STATE OF CONNECTICUT
CONNECTICUT SITING COUNCIL

IN RE: :
: :
APPLICATION OF CELLCO PARTNERSHIP : DOCKET NO. 410
D/B/A VERIZON WIRELESS FOR A :
CERTIFICATE OF ENVIRONMENTAL :
COMPATIBILITY AND PUBLIC NEED FOR :
THE CONSTRUCTION, MAINTENANCE :
AND OPERATION OF A WIRELESS :
TELECOMMUNICATIONS FACILITY IN :
THE CITY OF MILFORD, CONNECTICUT :
: DECEMBER 22, 2010

RESPONSES OF CELLCO PARTNERSHIP d/b/a VERIZON WIRELESS TO
CONNECTICUT SITING COUNCIL PRE-HEARING QUESTIONS, SET ONE

Proposed Verizon Wireless LTE (700 MHz) Coverage
 With Proposed Antennas At 110 Feet AGL
 Milford, Connecticut and Surrounding Area
 (Map Scale is 1:30,000)
 Coverage plot assumes 55% site loading on the Celco system

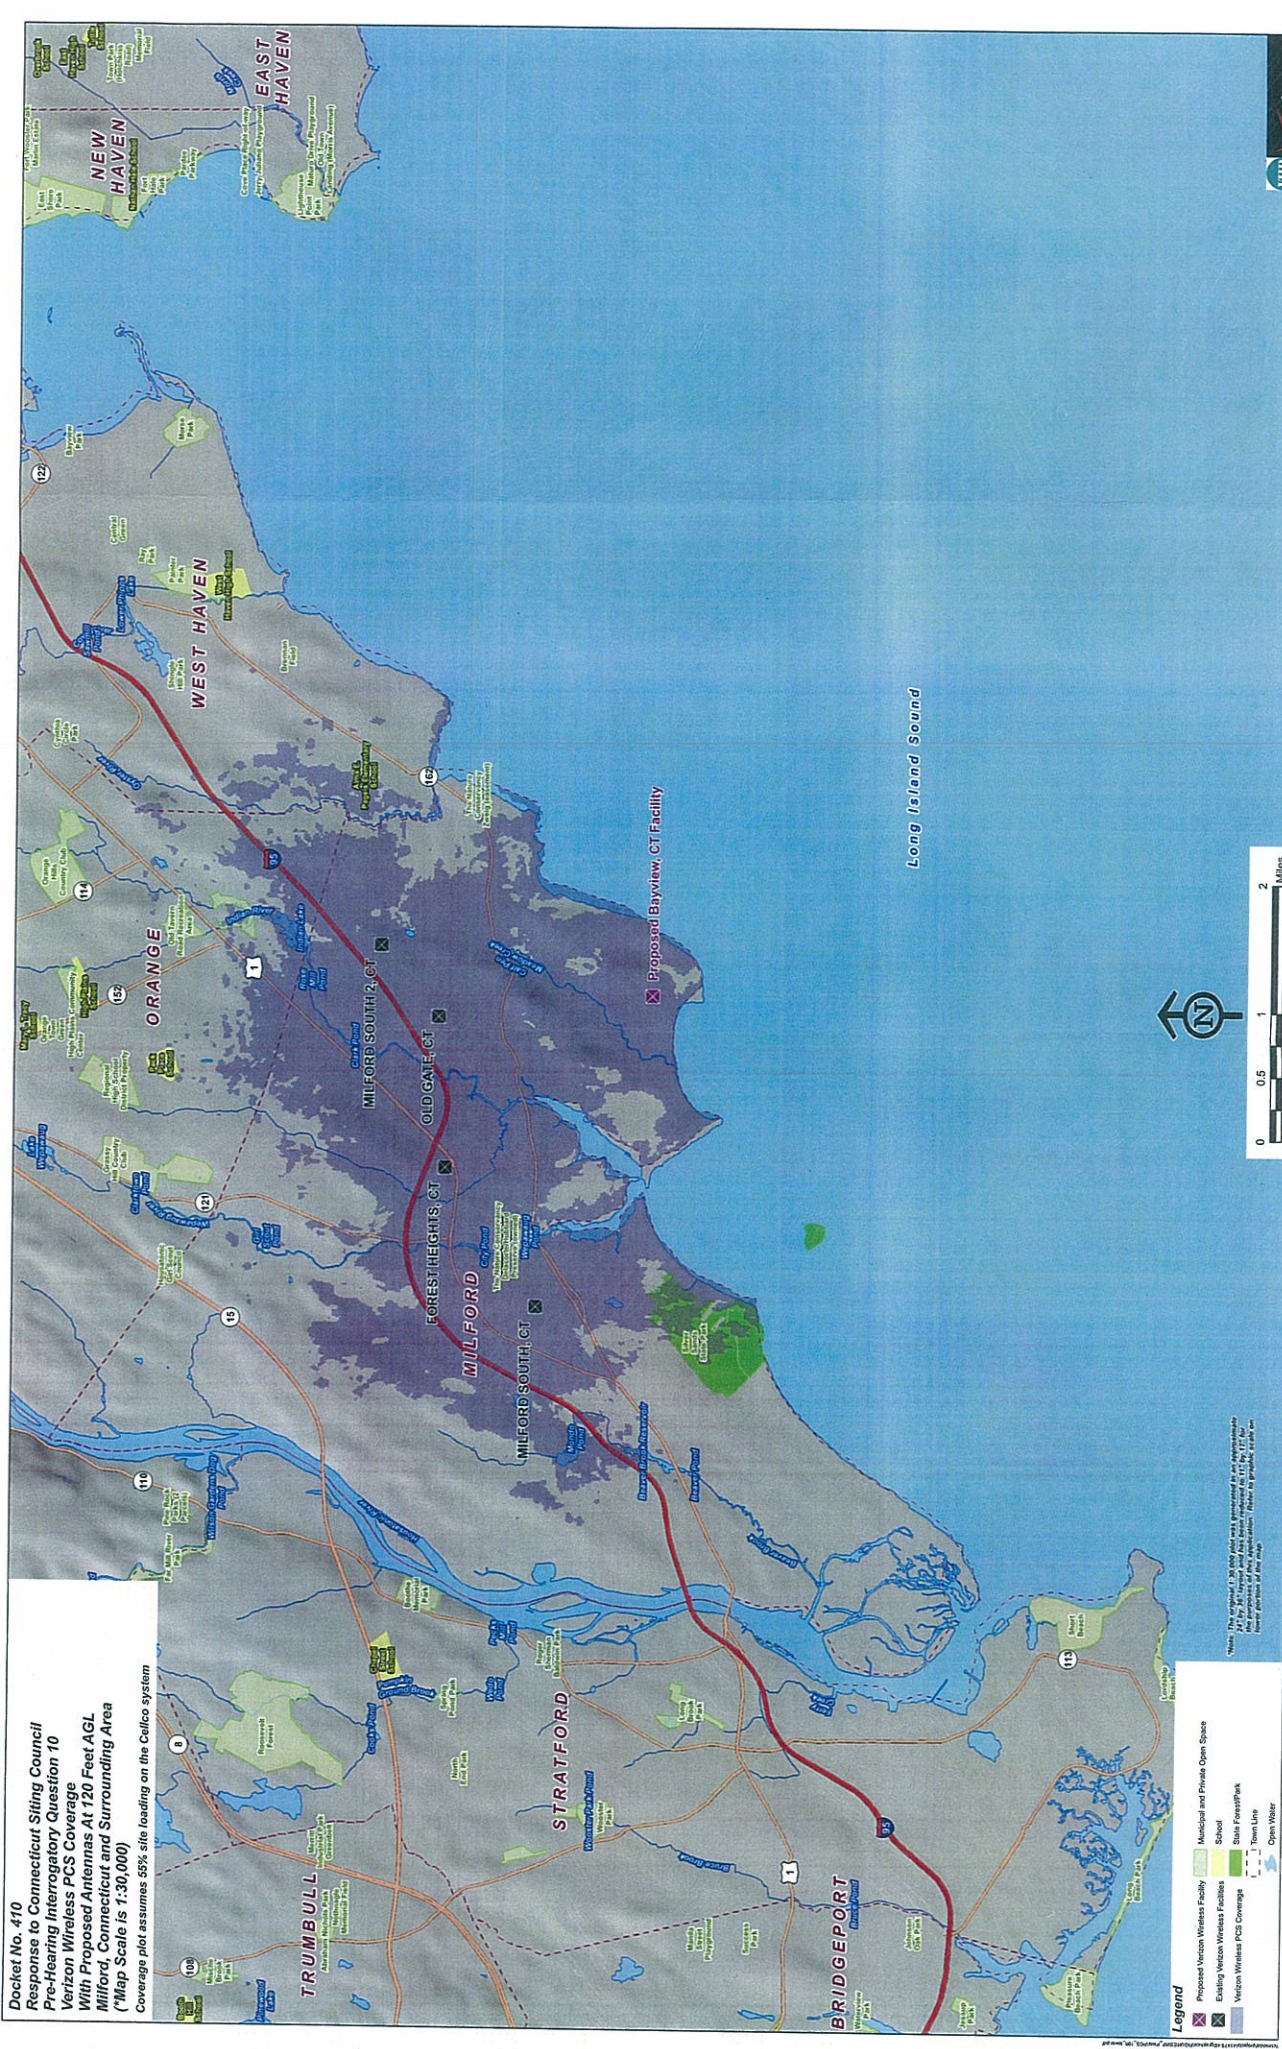
No existing LTE coverage map is provided. Is there any existing LTE coverage in the vicinity of the proposed tower? If yes, provide a plot of existing LTE coverage using the same scale provided.

Currently there is no LTE service being provided anywhere in the State of Connecticut. Cellco does anticipate that it will begin to activate its LTE network in Connecticut in 2011. If the Bayview Facility is approved, Cellco would install LTE (700 MHz) antennas at this site. Included behind Tab 2 is a stand-alone coverage plot showing LTE coverage from the proposed Bayview Facility.

Docket No. 410
 Response to Connecticut Siting Council
 Pre-Hearing Interrogatory Question 10
 Verizon Wireless PCS Coverage
 With Proposed Antennas At 120 Feet AGL
 Milford, Connecticut and Surrounding Area
 (*Map Scale is 1:30,000)
 Coverage plot assumes 55% site loading on the Celco system

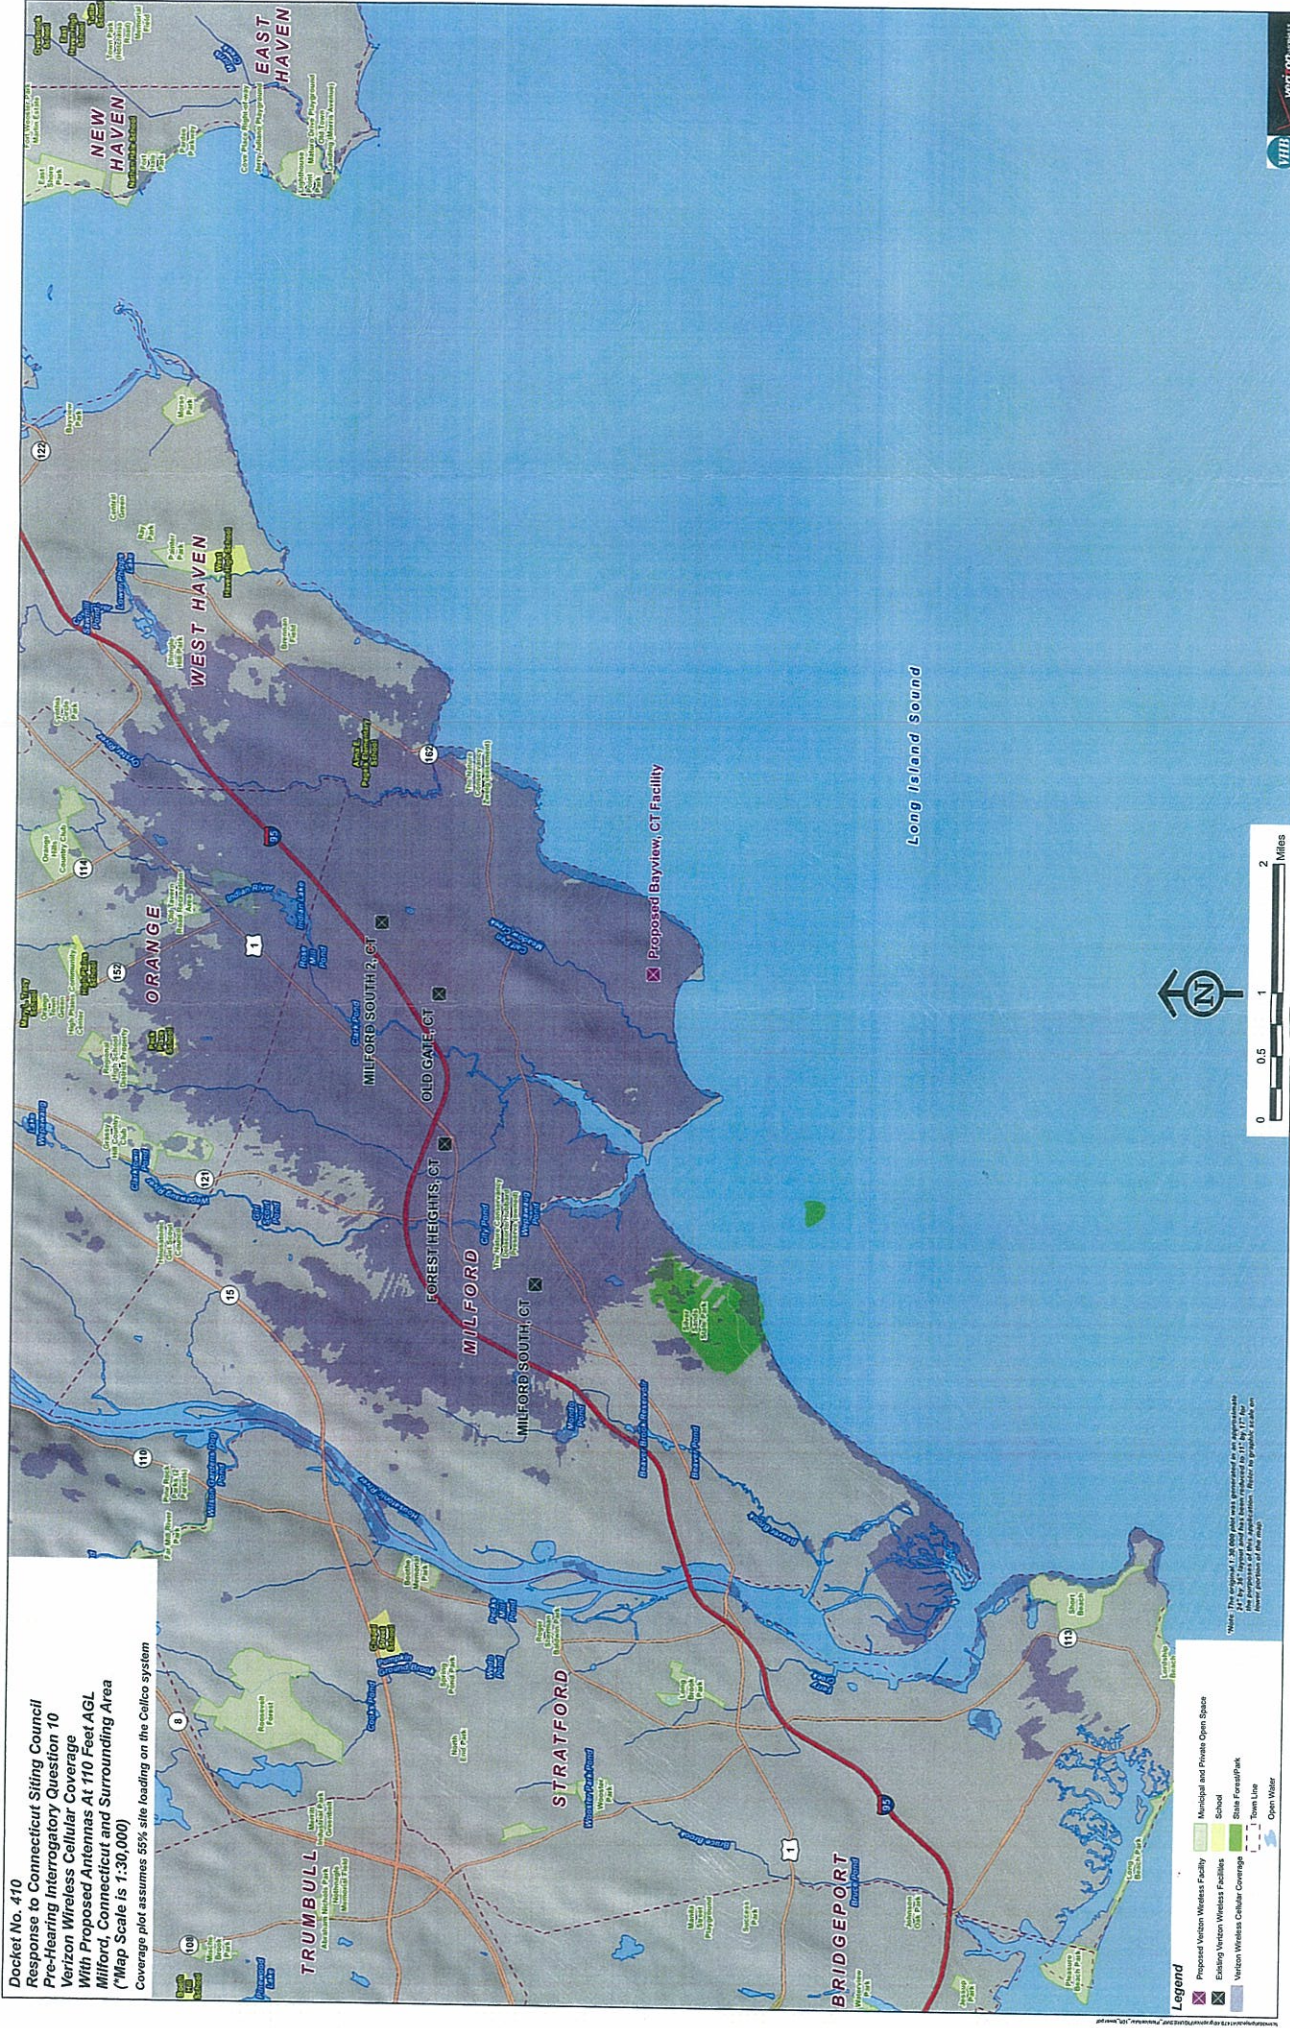
Provide cellular, PCS, and LTE coverage plots, as applicable, using the same scale provided assuming the tower is ten and twenty feet shorter, respectively.

Coverage plots assuming PCS, Cellular and LTE antenna heights ten feet lower than proposed in the application are included behind Tab 3. Coverage plots assuming PCS, cellular and LTE antenna heights twenty feet lower than proposed in the Application are included behind Tab 4.
